Service Bulletin

No.: MZ09-125

Model: UD9004

Subject: Correction of the Video DAC.

VIDEO PWB UNIT Assy (8U-310002AZ)

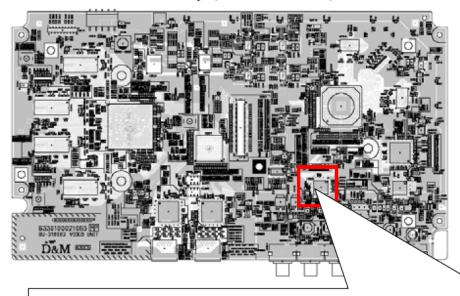
Symptom: The resolution of the component output is set to "1080i" and "source direct" the video setting. Then, the Pb/Cb output and the Pr/Cr output are interchanged.

- 1) Remove the "VIDEO PWB UNIT Assy (8U-310002AZ)". (Regarding DISASSEMBLY the unit, please refer the Page 5 of the Service Manual.)
- 2) Confirm the printed character on IC802 (Video DAC), check whether incorrect part is attached or correct part is attached on the VIDEO PWB UNIT.
- 3) Replace the IC802 to correct part if the incorrect part is attached.
- 4) Re-assemble the unit.
- 5) Turn on the power of the unit.
- 6) Set the setting of "Component Resolution" of the "Video Setup" to "1080i". Then check whether the color of the Pb/Cb and the Pr/Cr are output correctly.

Correct ("BSTZ-3" is printed)

Solution: Replace the Video DAC when the above symptom occurs and claimed by the customer.

Ref No.	Parts Number	Parts Name
IC802	2378 10002 609S	ADV7344BSTZ
